Submissions Report for the **Karuah South Quarry**

State Significant Development 17_8795

Submissions Report

State Significant Development 17_8795

Figure 4.1 Habitat Connectivity Post Development

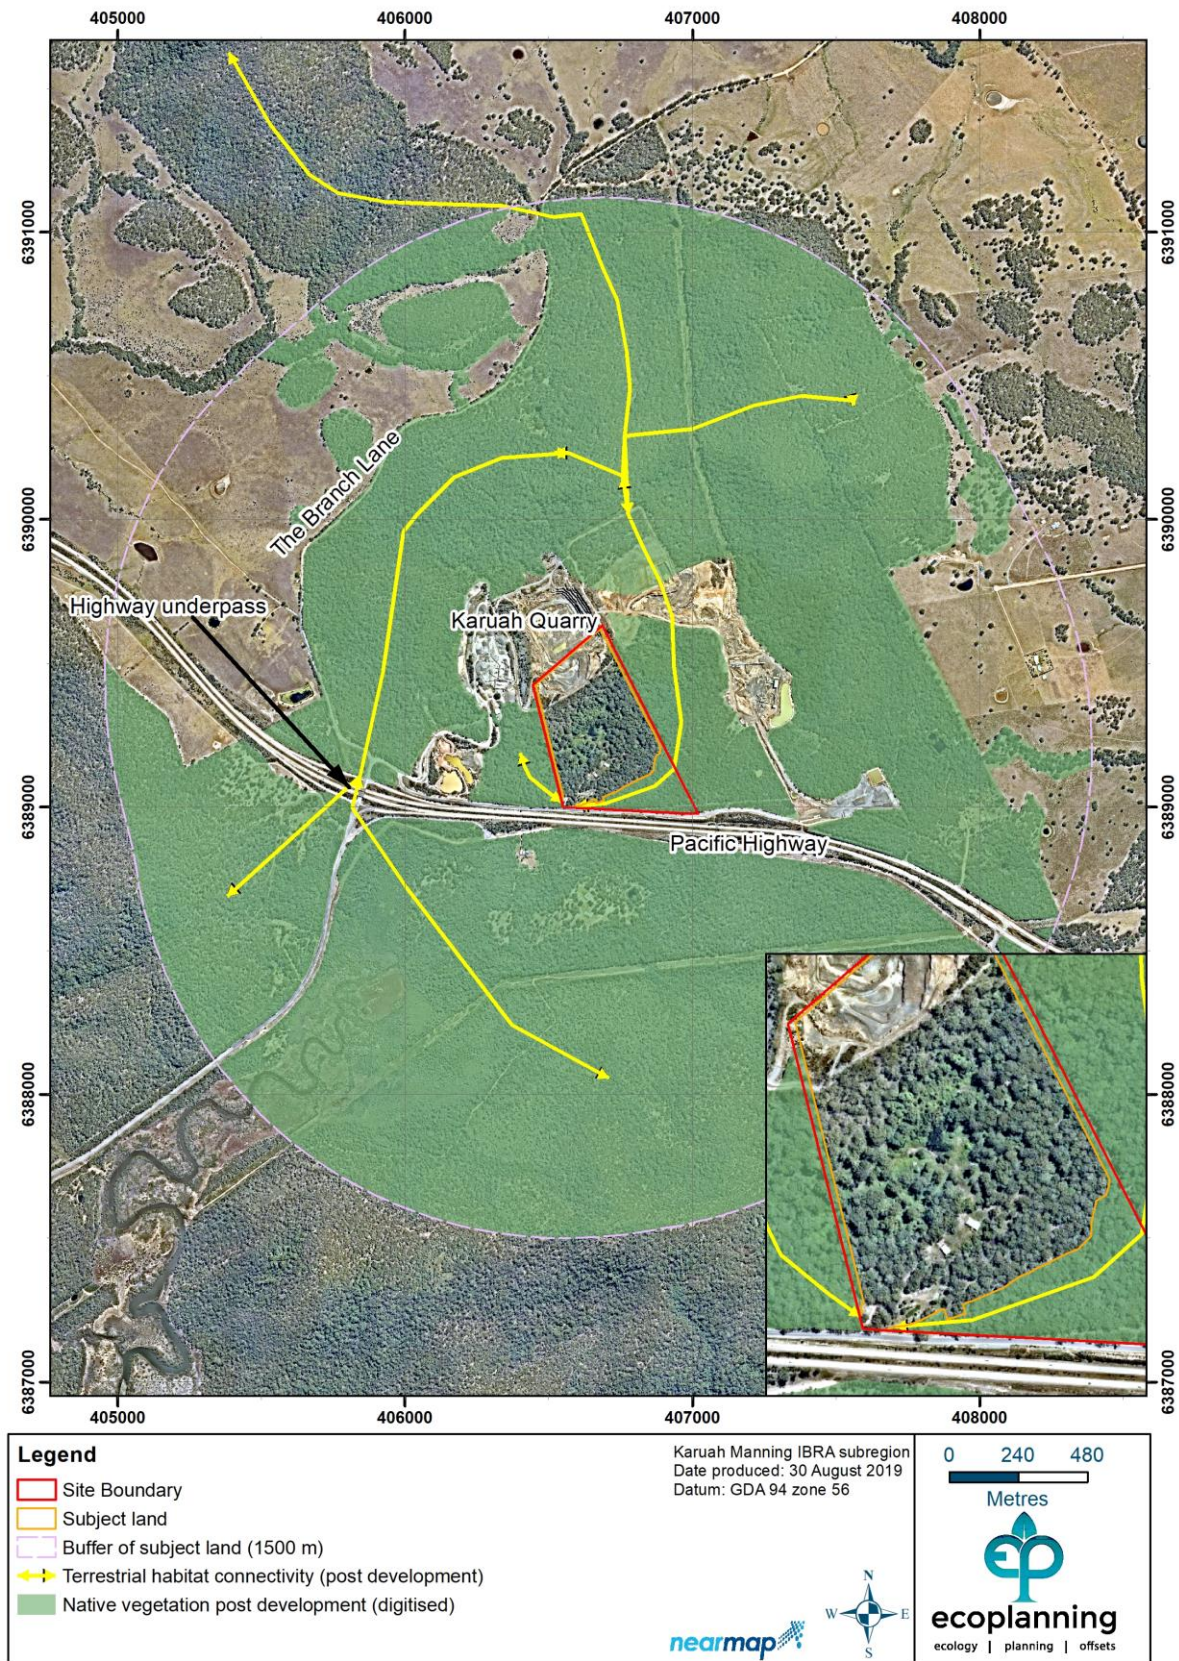
The BDAR Section 2.1.4 and Figure 4 identifies terrestrial habitat connectivity across the subject land (noting recent clearing has impacted this connectivity). It is unclear if connectivity to native vegetation southeast on the subject land and west of the subject land could be retained post development, or if this native vegetation will become isolated. An assessment of post development habitat connectivity is required as per Clause 6.1 of the Biodiversity Conservation Regulation 2017, specifically to address the gap between native vegetation retained on the southeast of the subject land and west of the subject land, potential isolation of native vegetation west of the subject land, and if fauna structures (such as rope bridges or glider poles) are required to maintain habitat connectivity.

An updated figure has been prepared to identify the post-development habitat connectivity within the proposed area of disturbance and surrounding area (**Figure 4 1**). This identifies that the vegetation retained in the south-east of the proposed area of disturbance would not be directly connected to vegetation to the west of the proposed area of disturbance, however these areas of vegetation would only be separated by the access route to the quarry with a canopy gap of approximately 37m.

As noted above, retention of vegetation along the southern boundary of the Site would still allow for potential Koala movement from the south-east of the proposed area of disturbance to vegetation west of the proposed area of disturbance, although it is noted that the corridor width within the Site would be greatly reduced and a canopy gap of approximately 37m would exist. No fauna structures are currently proposed across this canopy gap as it is less than the volplaning (gliding) distance for the Squirrel Glider and Yellow-bellied Glider. Additionally, given the preference for Koalas to move across the ground between canopy gaps, rather than across rope bridges or other fauna structures, no such structures are currently proposed. However, if the canopy gap and more importantly the gap between trunks of canopy trees exceeds 37m at the site entrance, such structures will be installed in consultation with DPIE.

Figure 4.2 Wind Direction and Surrounding Residences

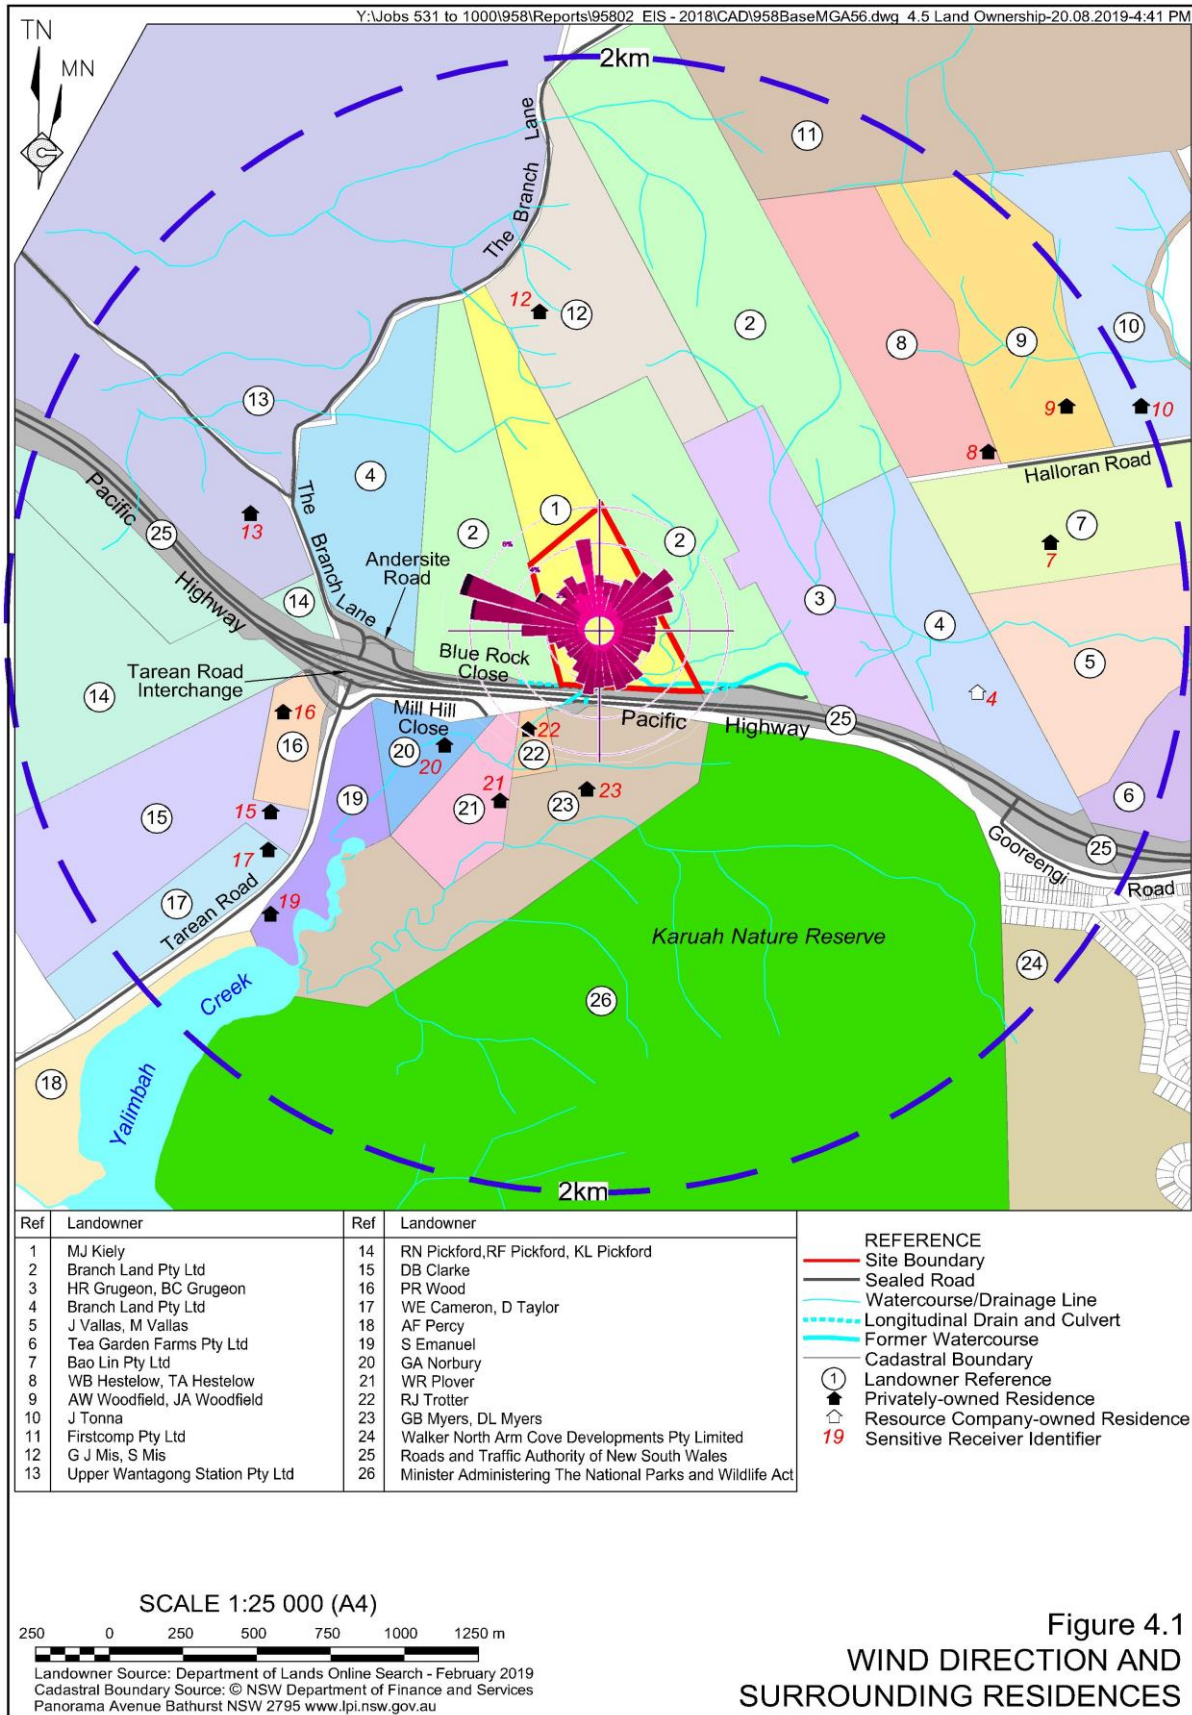
The nearest residence to the quarry's proposed area of ground disturbance appears to be less than 300 metres to the south, in Mill Hill Close. The RTS must provide details on how drinking water supplies (i.e. captured rainfall from roofs) would be protected from dust fallout generated by quarry operations.

The predicted rates of dust deposition at nearby receptors would be minor due to the range of particulate emission control measures which are proposed to be employed at the Quarry. A significant contributing factor to production is the prevailing wind direction. **Figure 4.2** presents the wind rose from the AQIA (Figure 6) superimposed on the land ownership figure. This combined figure effectively displays the predominant winds in the vicinity of the Karuah South Quarry would blow the bulk of the dust generated within the Quarry away from the residences south of the Pacific Highway.

The rate of dust deposition experienced at surrounding receptor locations resulting from the Karuah South Quarry is likely to be minor. The contribution of the Karuah South Quarry to the total dust rate of dust deposition experienced at surrounding receptors is also likely to be minor.

The Applicant would be prepared to enter into discussions with the adjoining quarry operators and to contribute to the cost of the installation of first flush rainwater harvesting systems at the most potentially affected residential locations where such systems are not currently installed. No other controls would be required at the surrounding residences as suggested.

Figure 4.3
PM₁₀ Frequency Distribution - Wallsend, Beresfield, Singleton and Singleton NW

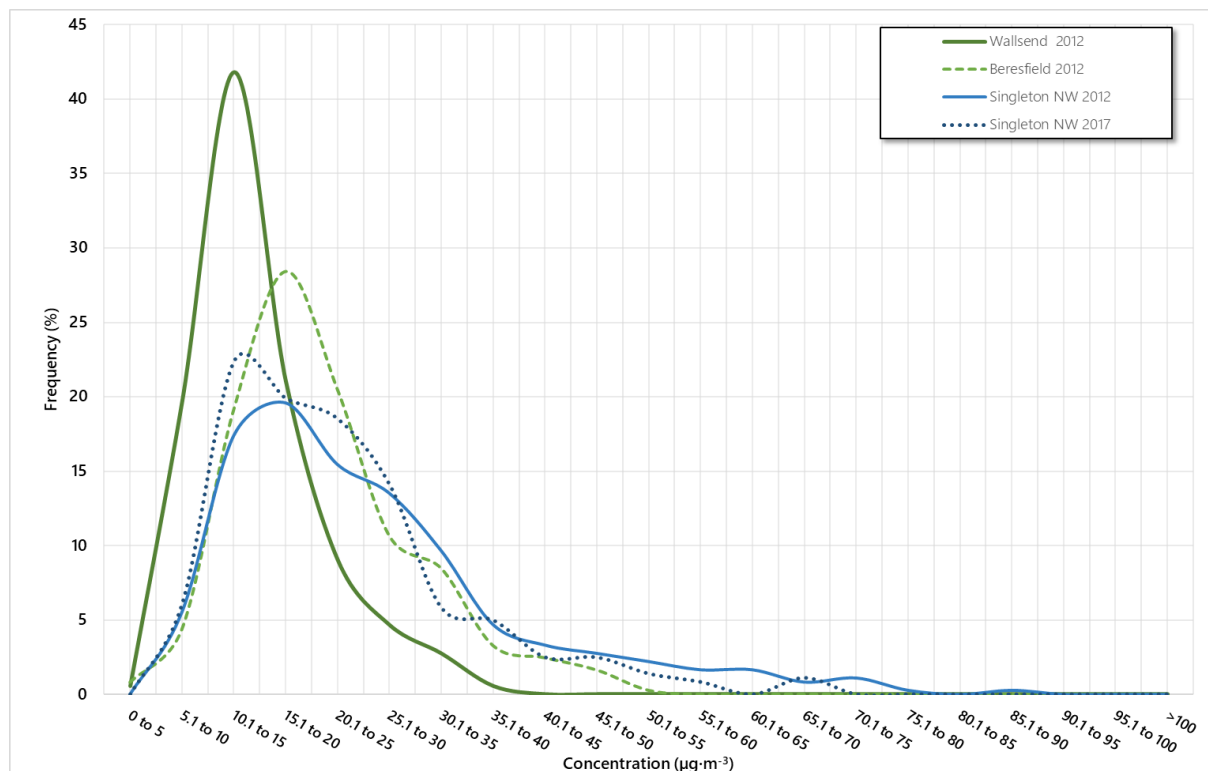
- *Revised dispersion modelling to include production scenarios for the Karuah Quarry and Karuah East Quarry that reflect their maximum operating capacities (current approach does not reflect worst case scenario).*
- *Additional information to support the use of the equivalence background dataset.*

Continuous PM₁₀ data measured at the Singleton NW AQMS during 2017 has been critically reviewed. A frequency distribution of the PM₁₀ measured at the Singleton NW AQMS in 2017 and 2012 (the year subject to detailed modelling in the AQIA for comparison), Wallsend AQMS in 2012 (the AQMS from which data were obtained and adjusted to support the AQIA), and Beresfield AQMS in 2012 (for comparison) is presented in **Figure 4.3**.
